MEMORANDUM

SUBJECT: **Maple Rd. & Chester St. Landscape Improvements**
Contract #3-15(P)

Architectural Review Committee

SUBJECT: **Maple Rd. & Chester St. Intersection**
New Landscaping for Southwest Corner

CHESTER STRUCTURE: MAPLE / CHESTER CORNER

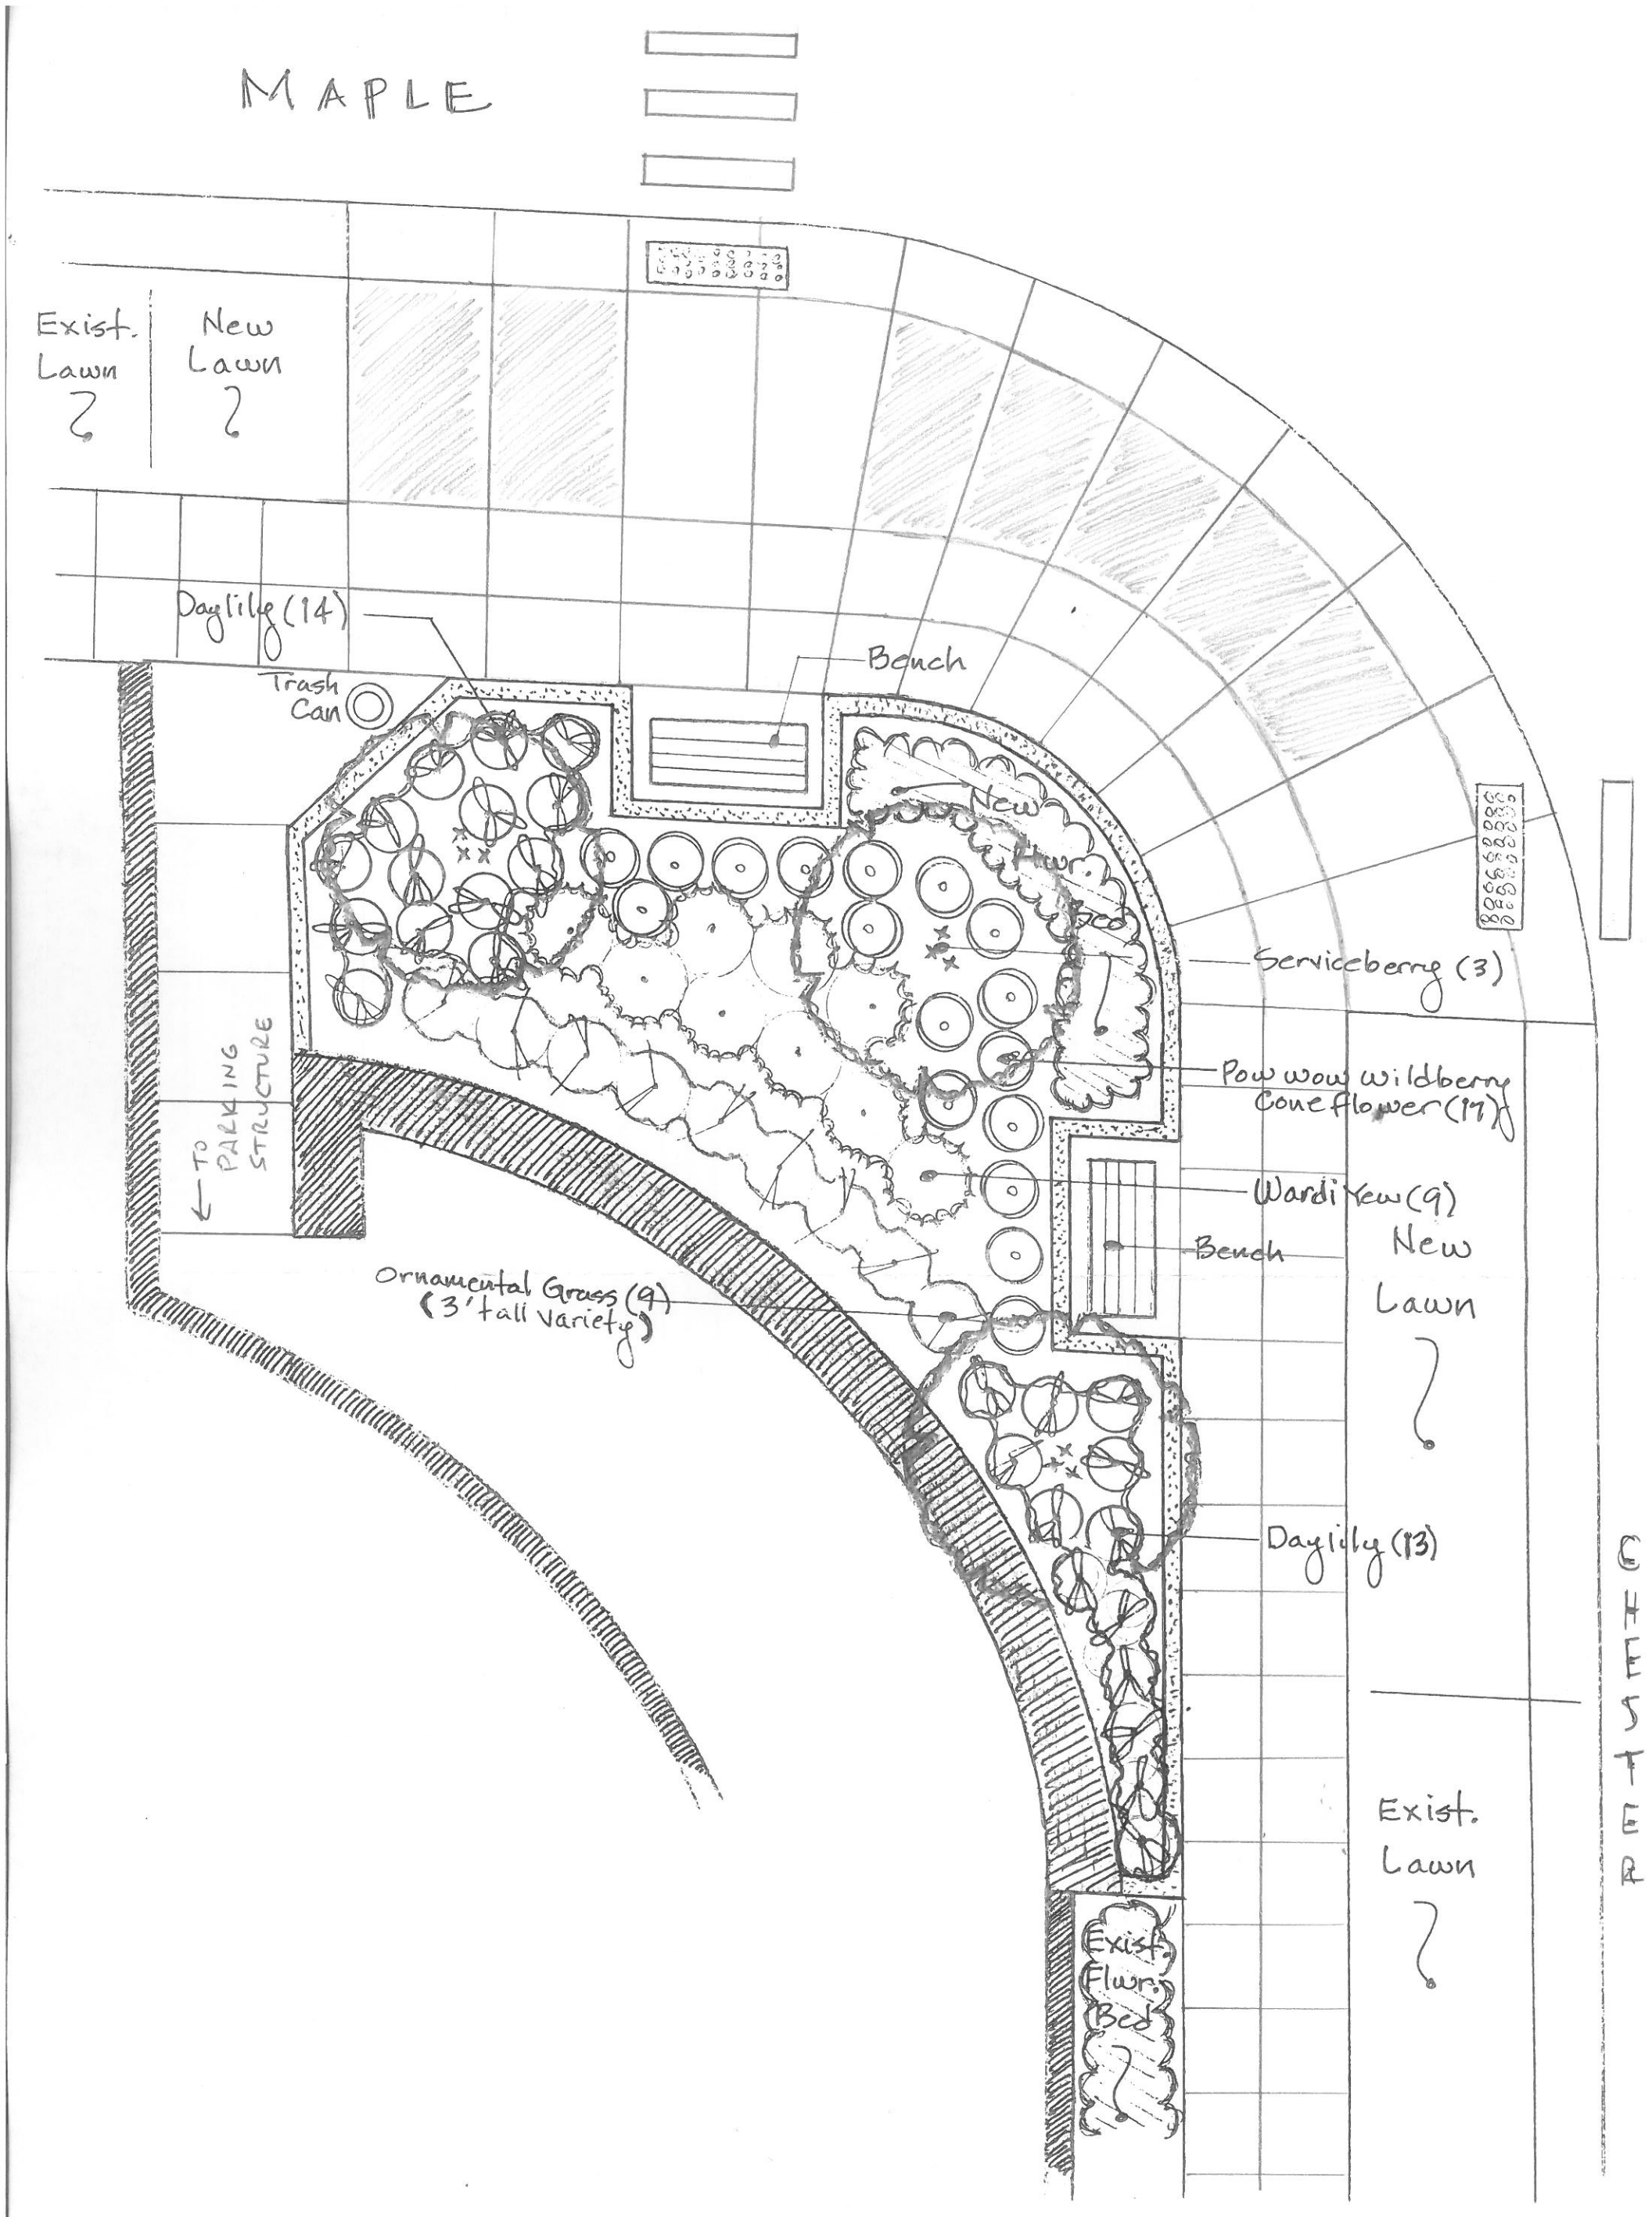
A similar design was brought before the Architectural Review Committee (ARC) on November 6. Draft minutes are attached. Adjustments to the design have been made based on their input. One item brought up by the ARC was the potential opportunity to install a bumpout into Chester St., given the presence of a parking lane to the south of this area. The Engineering Dept. advises against this due to the fact that this is still a common right turn for large vehicles. The reduction in space from what is there presently is significant. Further, the common presence of vehicles waiting in the northbound Chester St. left turn lane means that large vehicles would be squeezed to where driving over the curb could become a common occurrence. Given the high

traffic at this intersection, and since this design already reduces the Chester St. crosswalk length by 21 ft. (a 33% reduction), we feel that this is a good compromise.

S.W. CORNER CHESTER / MAPLE DETAIL

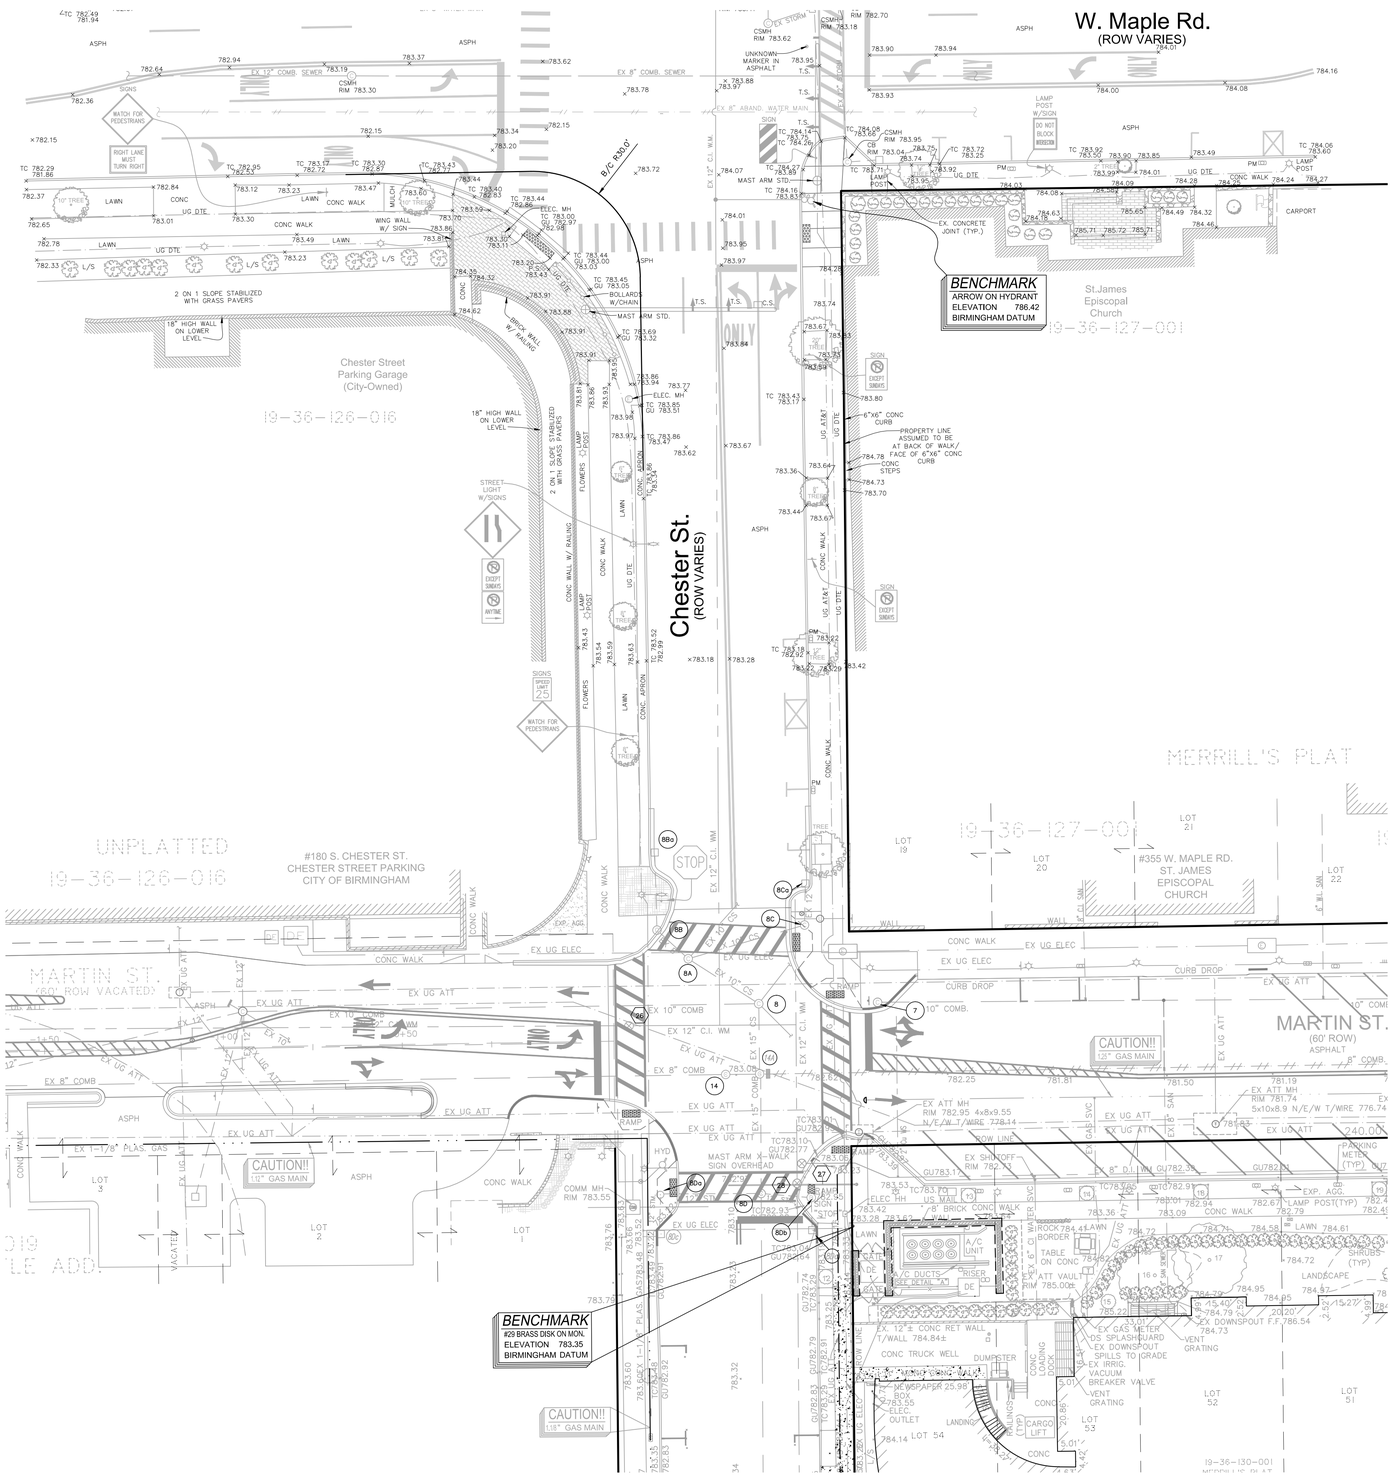
To streamline the design process, a survey of the area was obtained (attached). The inset view in the upper right corner of the survey sheet has a line showing the proposed new curb line. The attached landscape plan was prepared by Parks Dept. Assistant Foreman Mike Jurek. The design carries the theme started on the northwest corner, using the same concrete and plant materials installed there. As a side benefit of the project, a substantial brick paver area (the last remaining one on this block) will be removed and replaced with the sawcut concrete/exposed aggregate theme being used throughout downtown.

CHESTER STRUCTURE: MAPLE / CHESTER CORNER

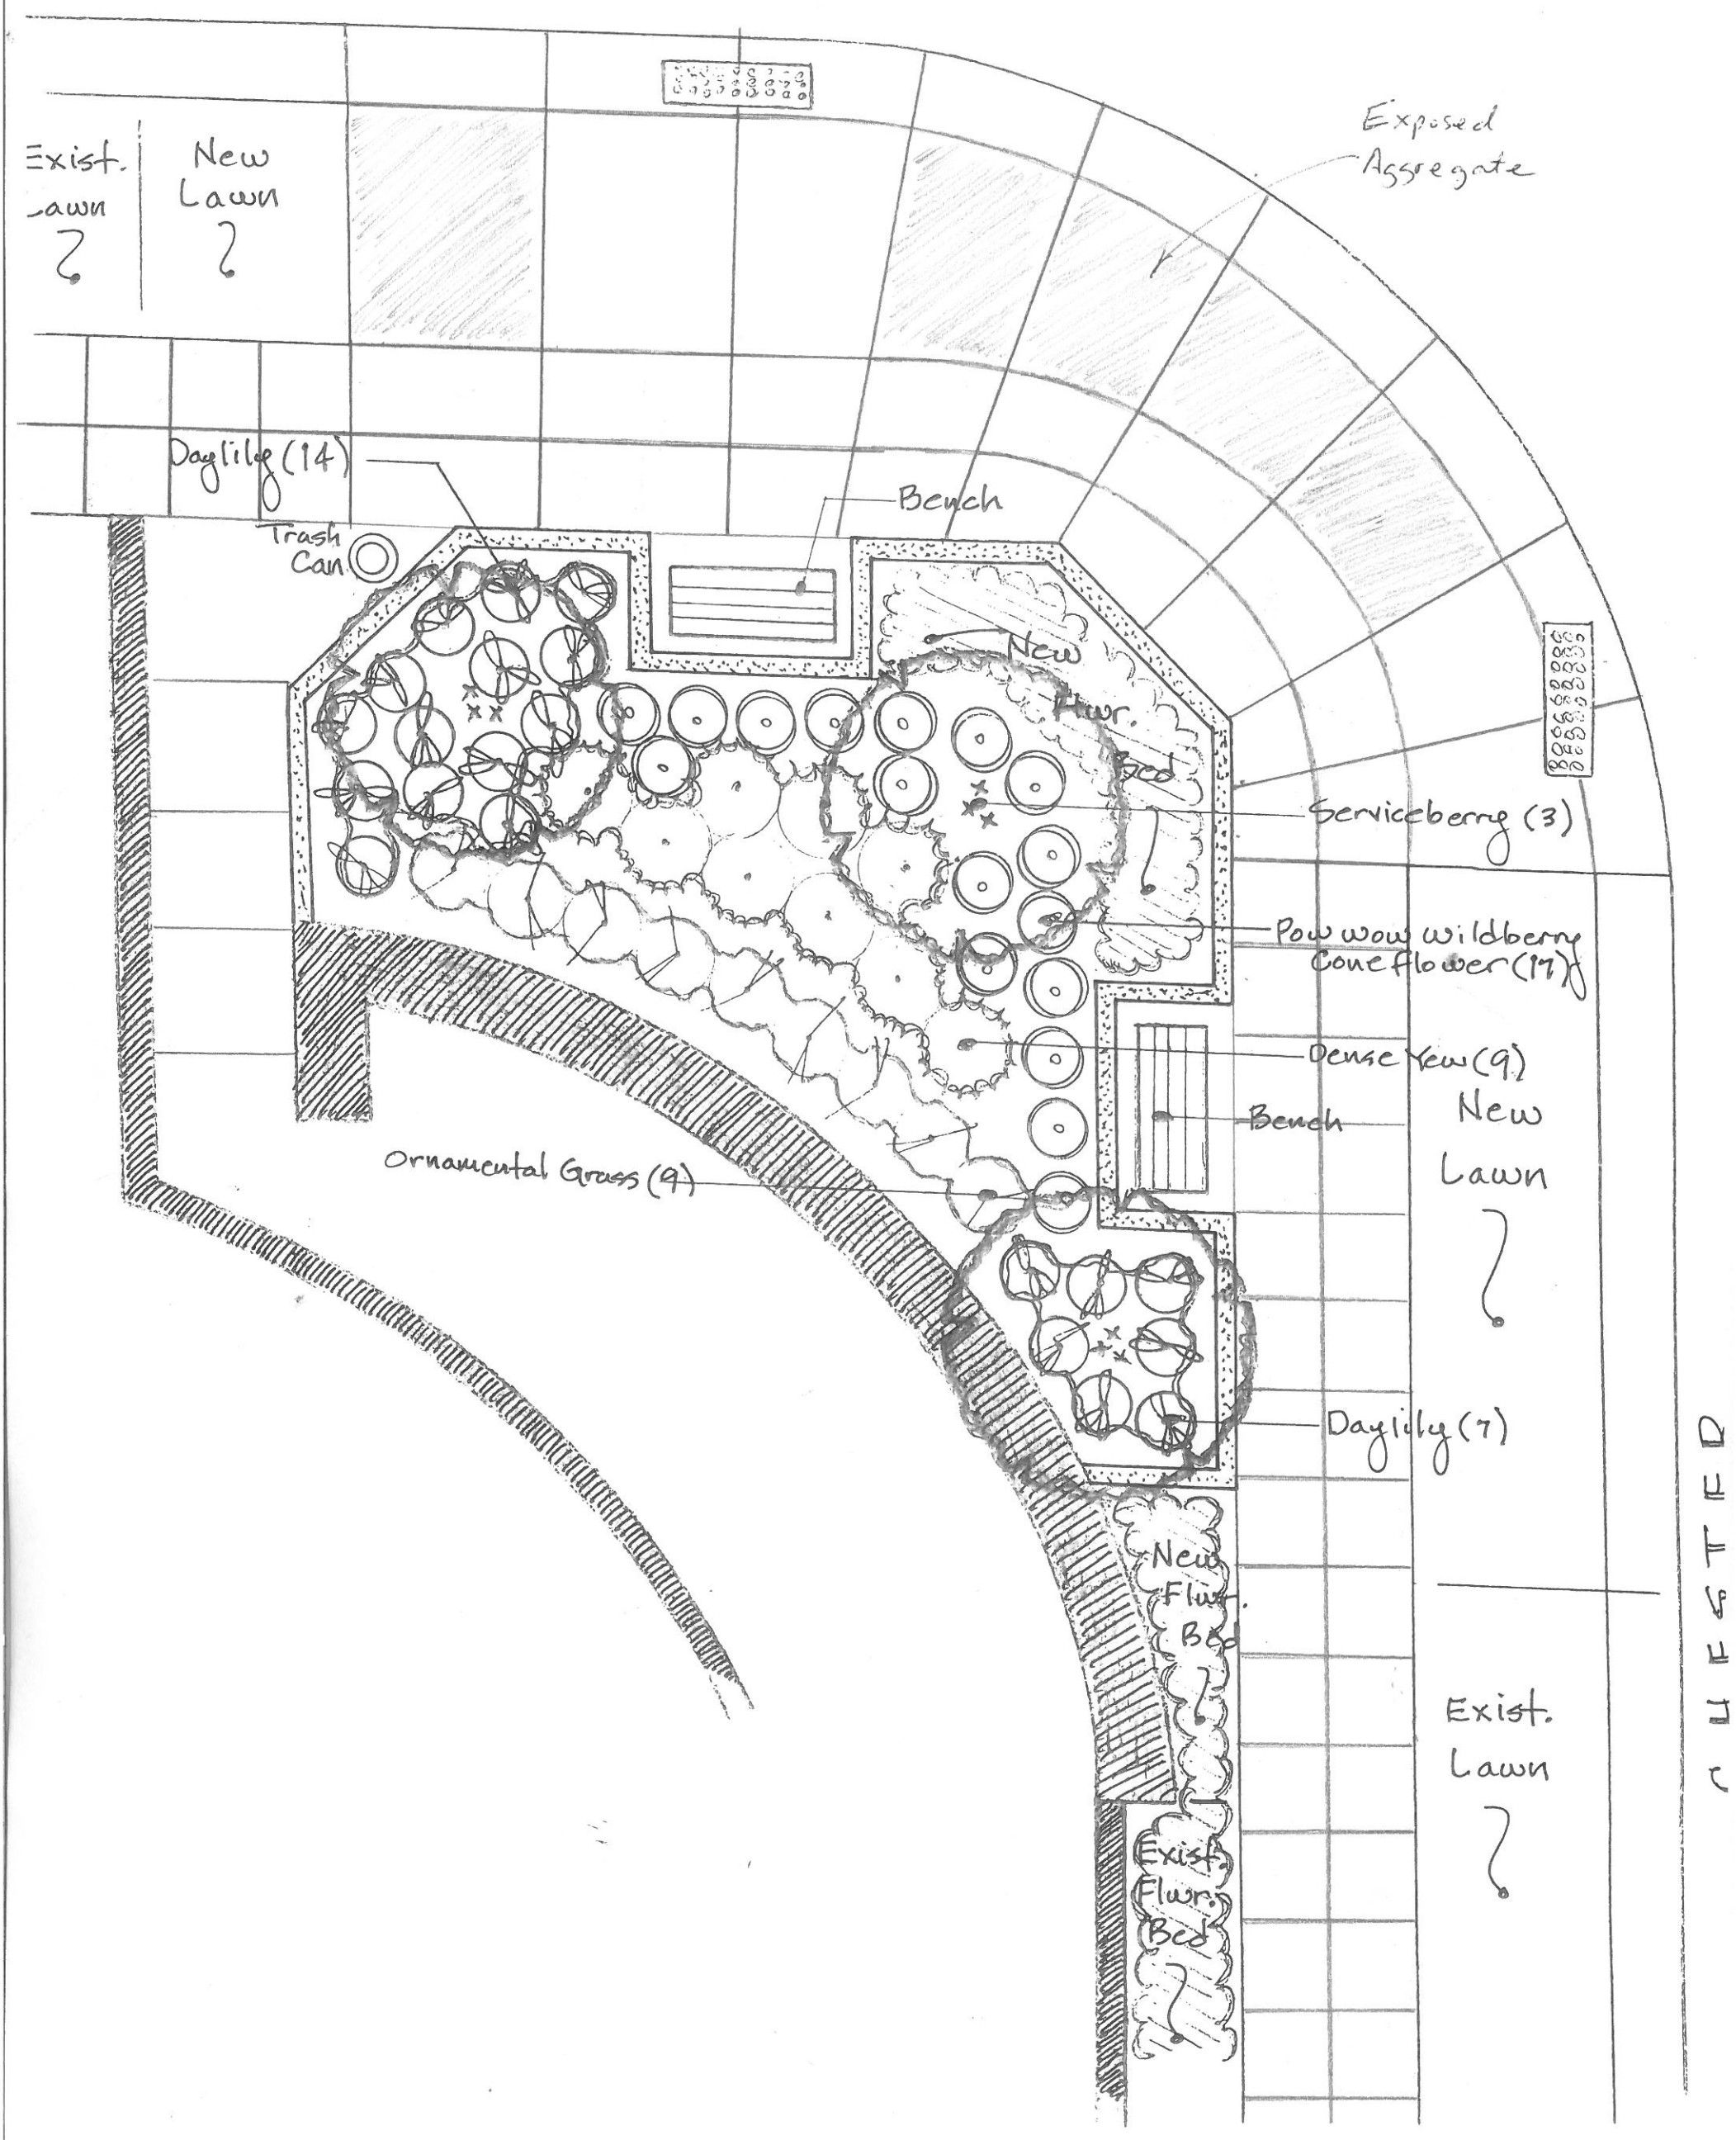
Mr. Longe asked if a bulb-out could be built since there is a parking lane on Chester St. Mr. O'Meara explained that the plans must be conscientious of truck traffic and the available turning radius; as this turn still has a demand for right turning trucks.

1. **Extend the planter curb south on Chester to meet the existing parking structure retaining wall.**

2. **Remove the 45° angle curb section in favor of a radius, matching the radius of the street.**

1. **Extend the planter curb south on Chester to meet the existing parking structure retaining wall.**

2. **Remove the 45° angle curb section in favor of a radius, matching the radius of the street.**
